SECTION 009113 – ADDENDUM TWO

- A. Project Name: 22034.02 Meridian High School
- B. Owner: Meridian Public School District, 1019 25th Avenue, Meridian, MS 38391
- C. Architect: Dale | Bailey, an Association, One Jackson Place, Suite 250, 188 East Capitol Street, Jackson, MS 39201-2100
- D. Architect Project Number: 22034.02
- E. Date of Addendum Two: 7 September 2023

MOMENT FRAME #4
SCALE: 1/8"=1'-0"

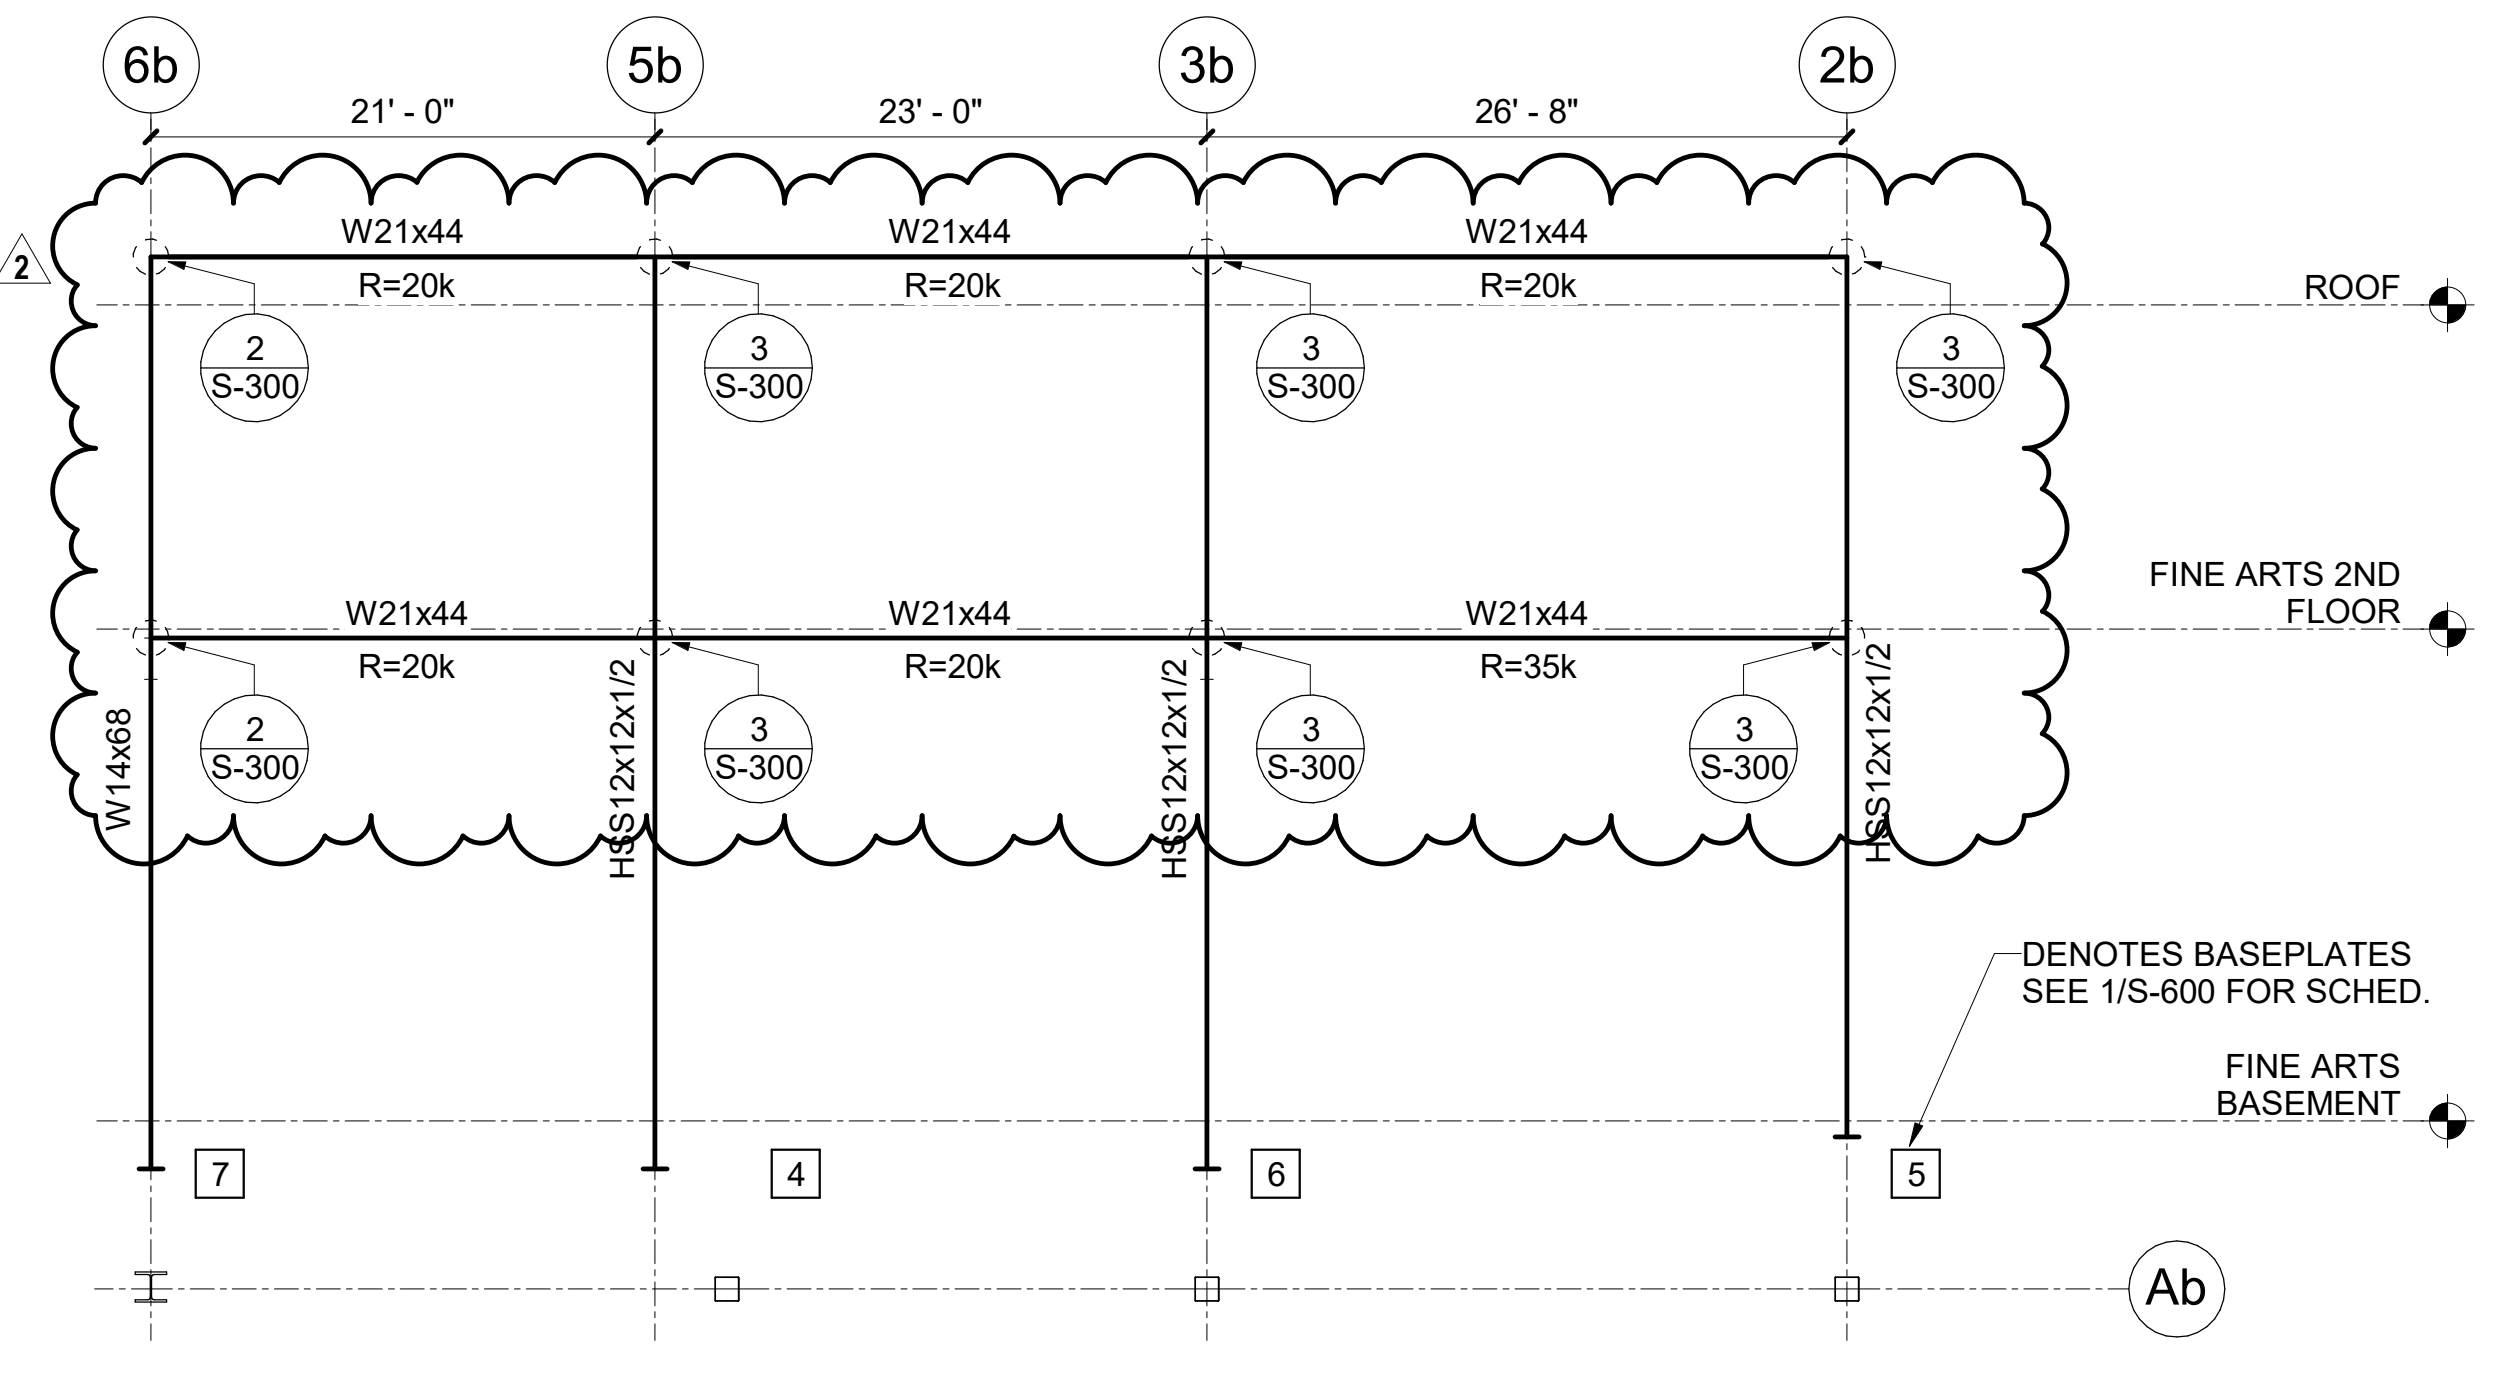
- D. Sheet S-602 – Moment Frame Elevations. (Revised). Delete this sheet in its entirety and replace it with attached. Indicated Moment connection details on moment frame elevations. Added cantilever beam sizes and reactions.

A-100

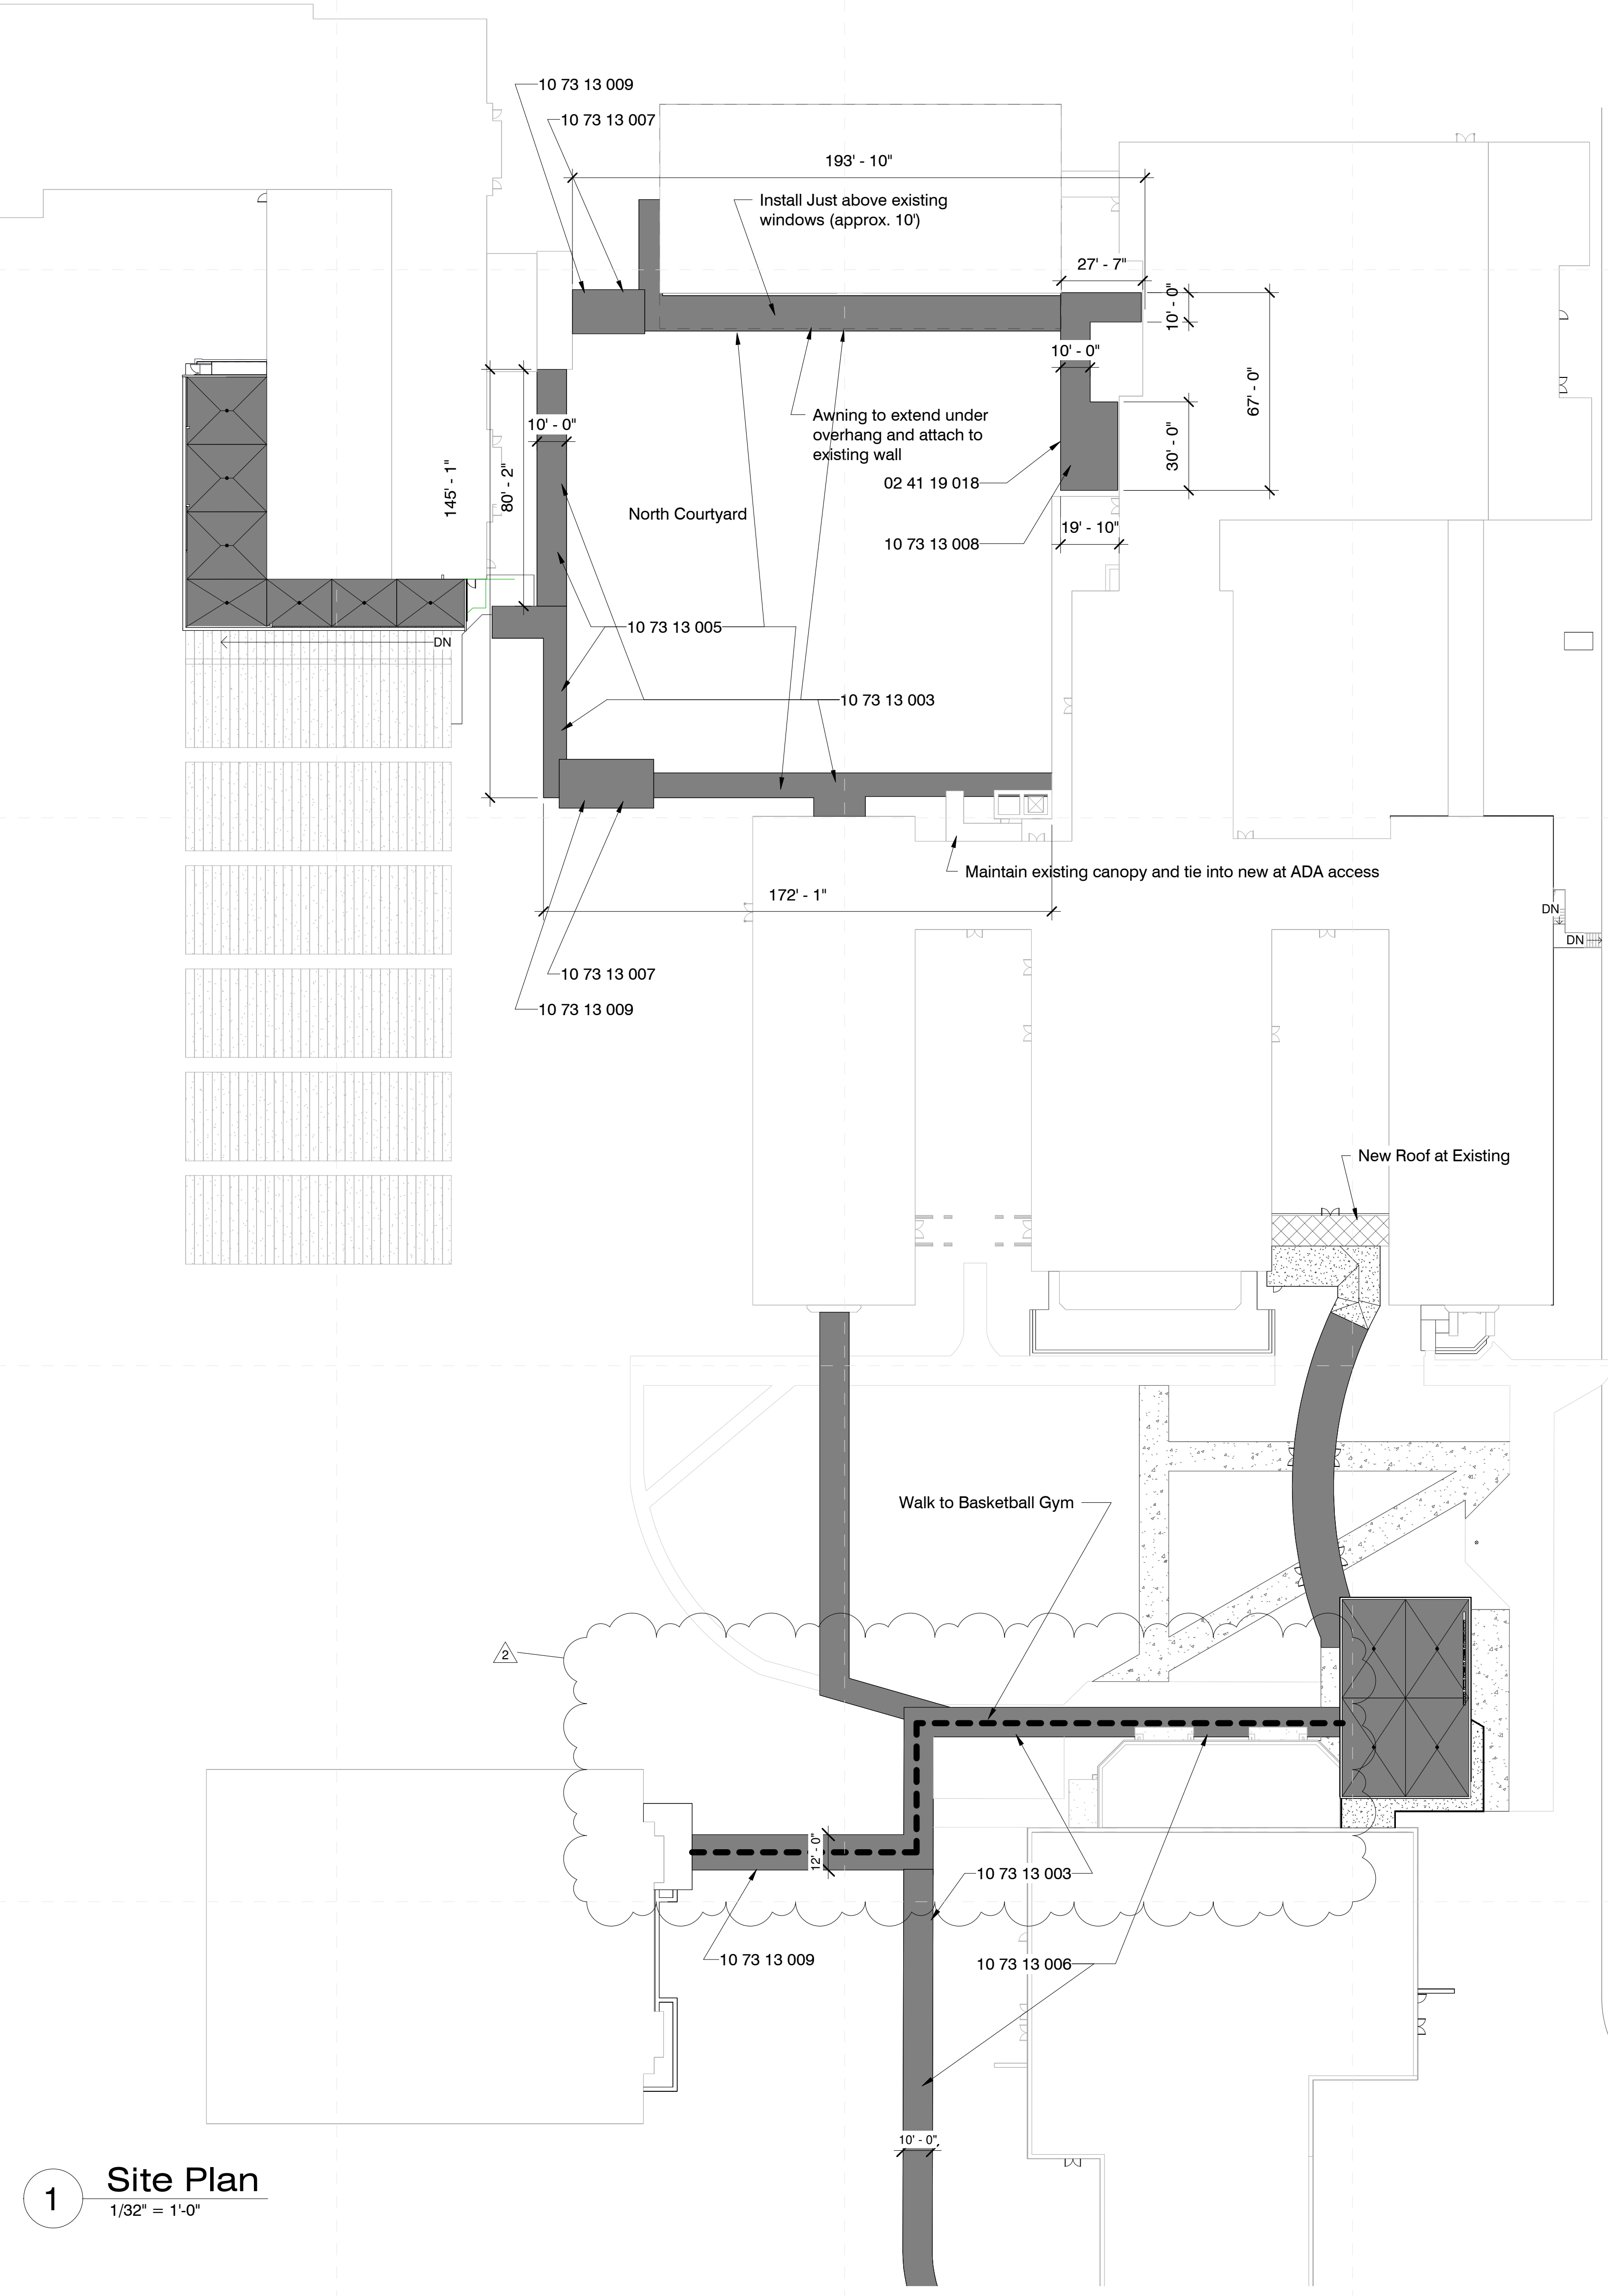
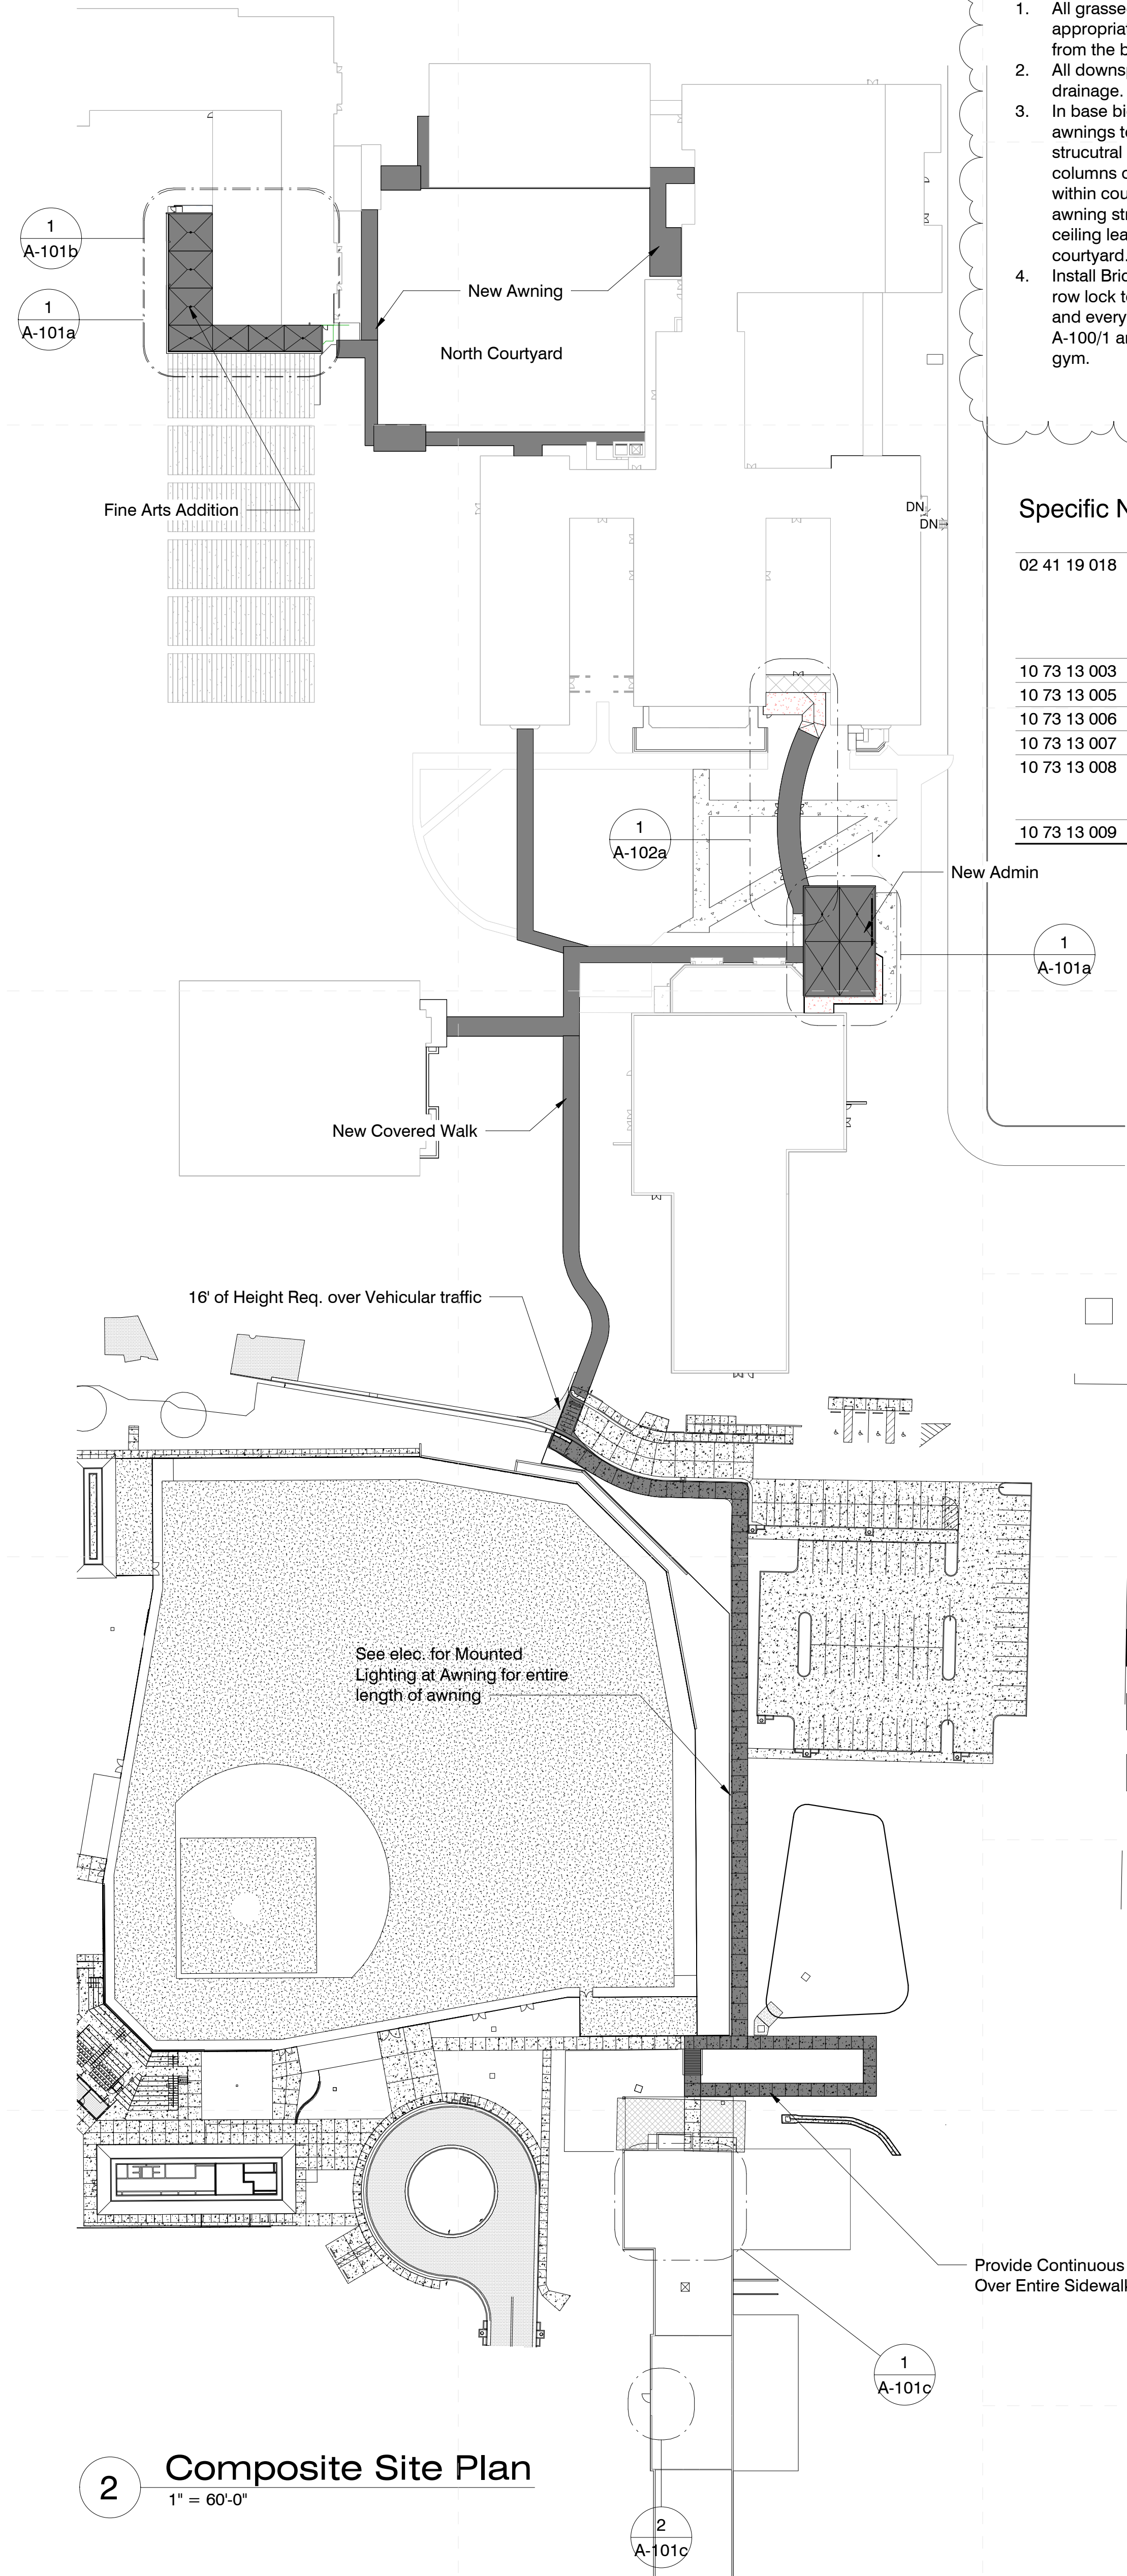
- E. Sheet A-100 – Composite Site Layout. (Revised). Delete this sheet in its entirety and replace it with attached. Added paint work to north court awnings.
